From: Shannon McIntyre
City of Mobile Architectural Engineering Department

Re: Mims Park – Athletic Restrooms and Concessions

Project #PR-048-24B

Date: November 12, 2024

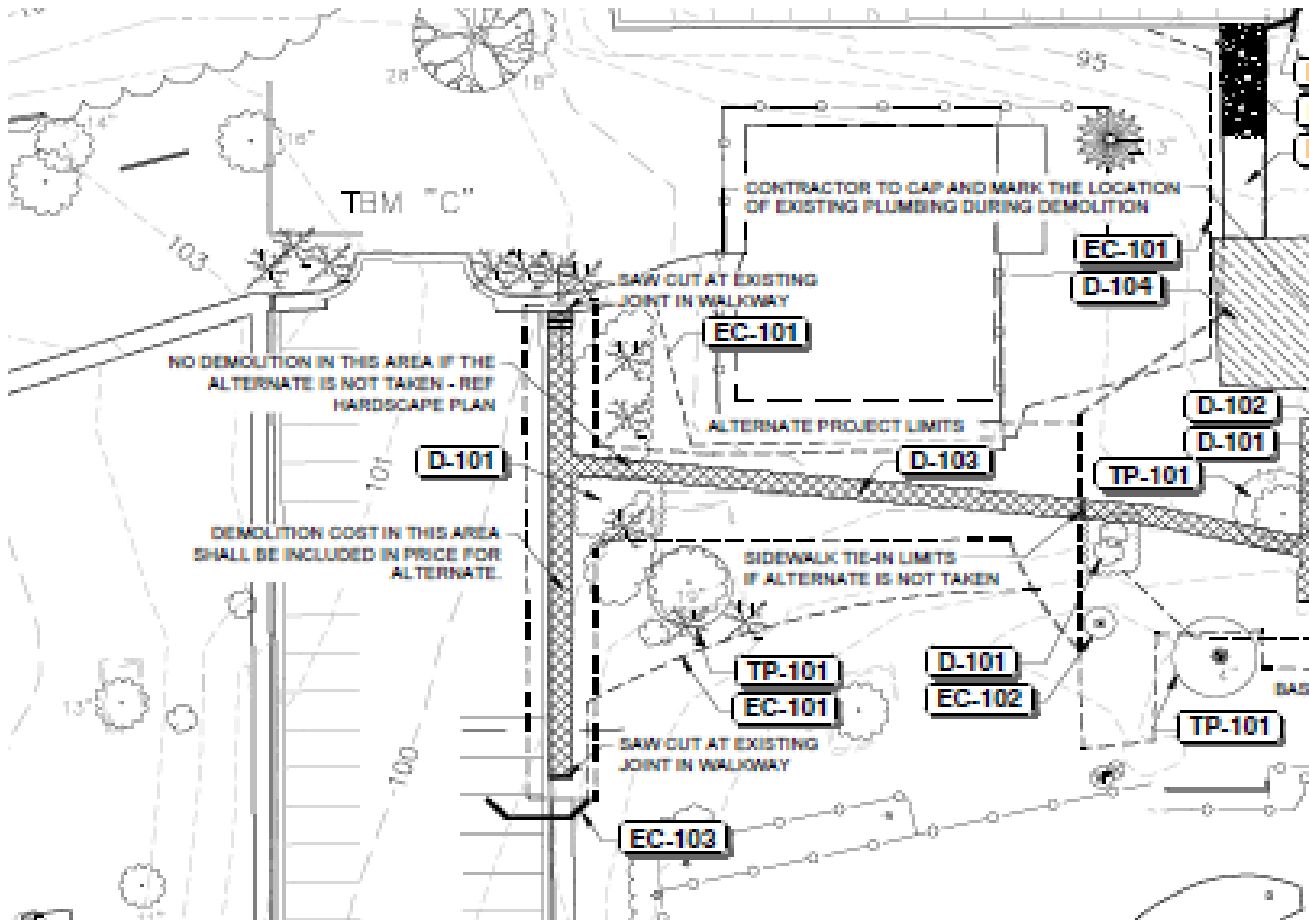
Q: Please clarify which part of the sidewalk is part of alternate 1? Is it just the section between the new building and the parking lot or does the alternate include removing all sidewalks to the parking lot and along parking lot, installing new curb, stairs and all new sidewalks?

A: Sheets, D100 and H100 - outline the limits of the area included in the alternate. The demo of walks and curbs, sidewalk construction, striping, steps, and all construction aspects within the alternate boundary shall be included in the price for the alternate. A screen shot of the outlined

area is shown below.

SECTION THROUGH EXTERIOR FOOTING F3 @ EXTERIOR 12" CMU WALL ON MIMS, REFERENCE SHEETS: S1.1 & S1.2

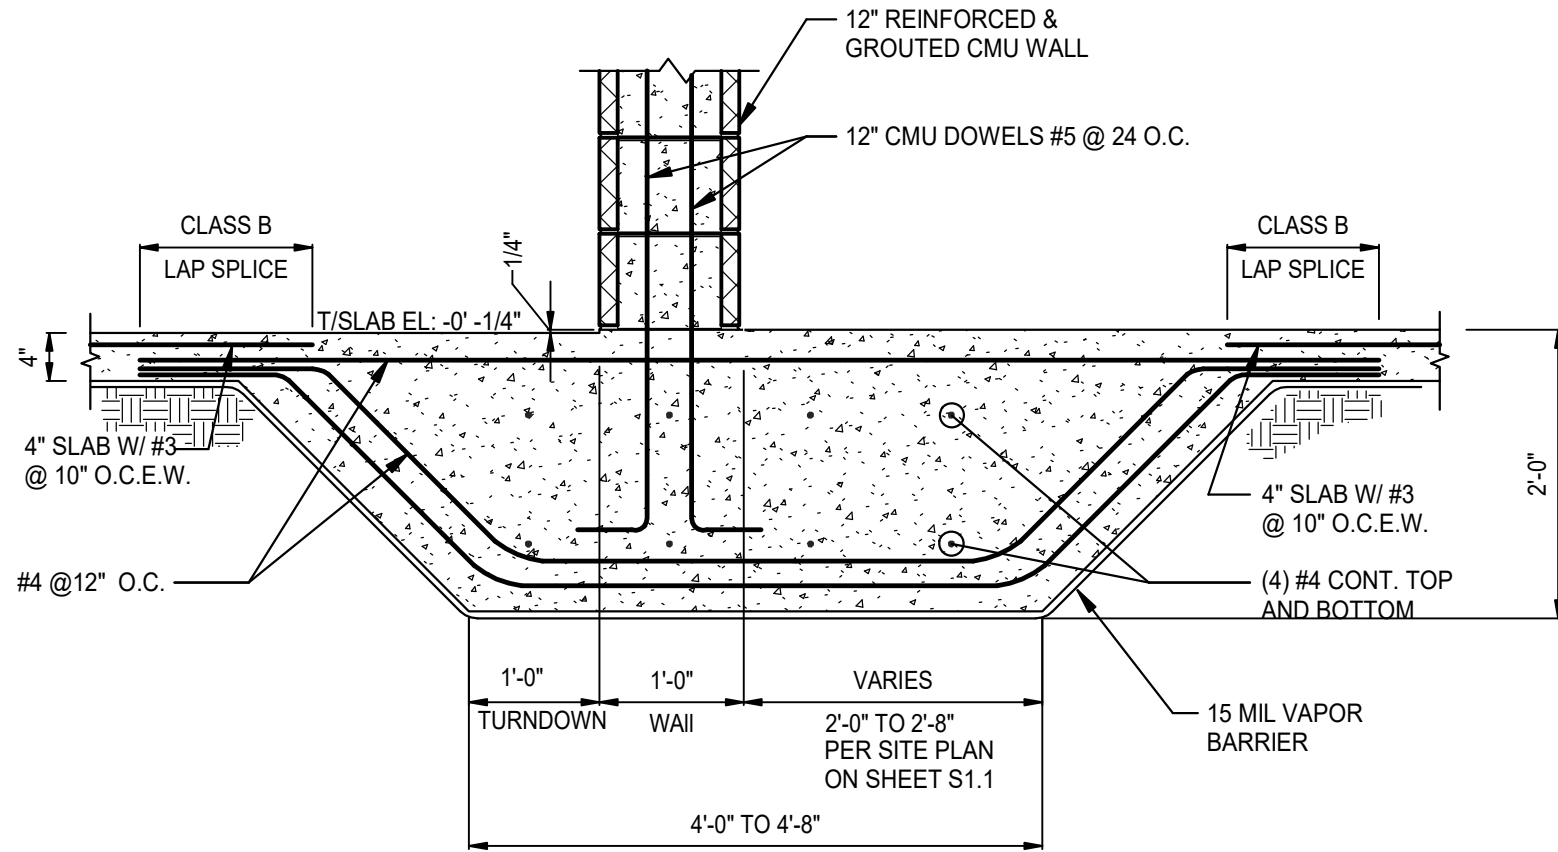
Please clarify the footing size and location. Please provide details of the footings. Please provide a detail of P1 with the 10 #7 around the perimeter.

A: Reference supplemental Amendment 4 Footing Details attached. Details to be stamped and incorporated in the final plans before construction.

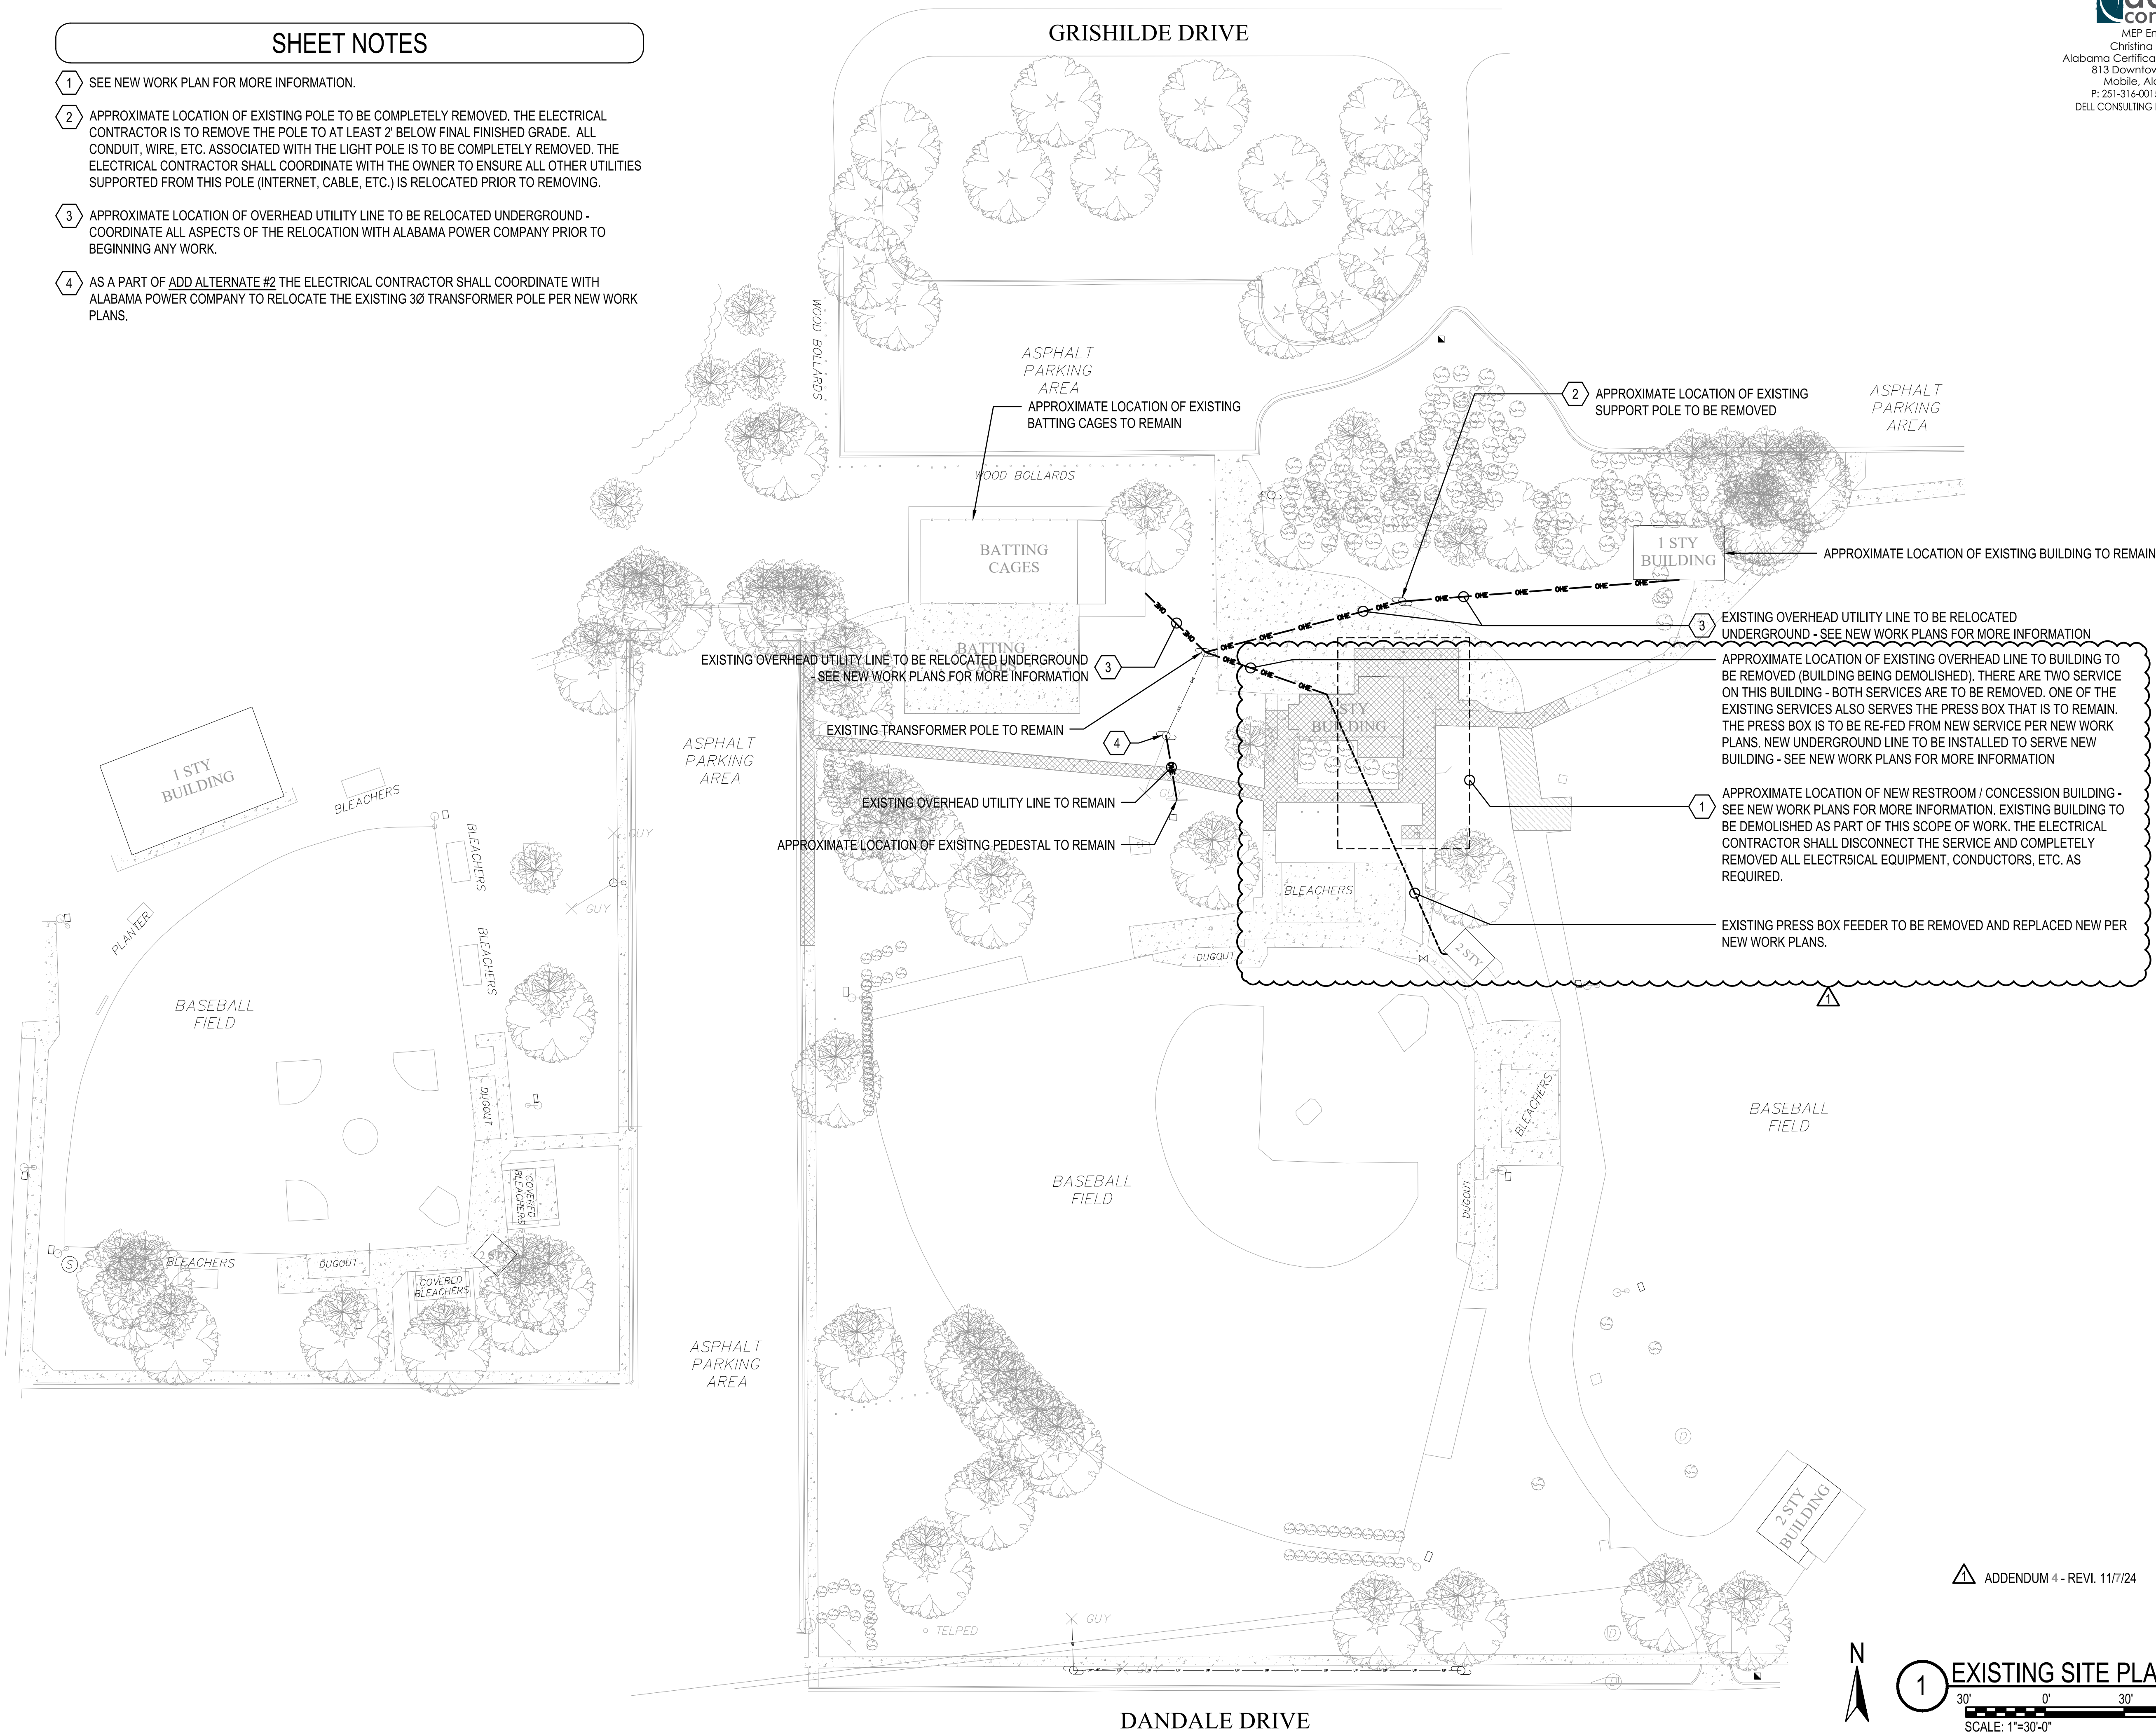
Q: I have included three pics from the ballpark. One of each service of the building that's going to stay, the batting cage, and the building that's being demolished. Currently on the building being demoed there are 2 meter bases that are being fed from the utility pole. Please clarify what these two-meter bases are feeding. We would like to confirm that one of them is not feeding something else in the park that will require power.

A: Both services are to be completely removed. The press box south of the concession building is currently fed from the service the serves the restroom lights.

The feeder for the press box is to be removed, relocated and replaced new per revised electrical plans included in this addendum. Sheets E3.0, E4.0, & E7.0 have been revised to reflect these changes.
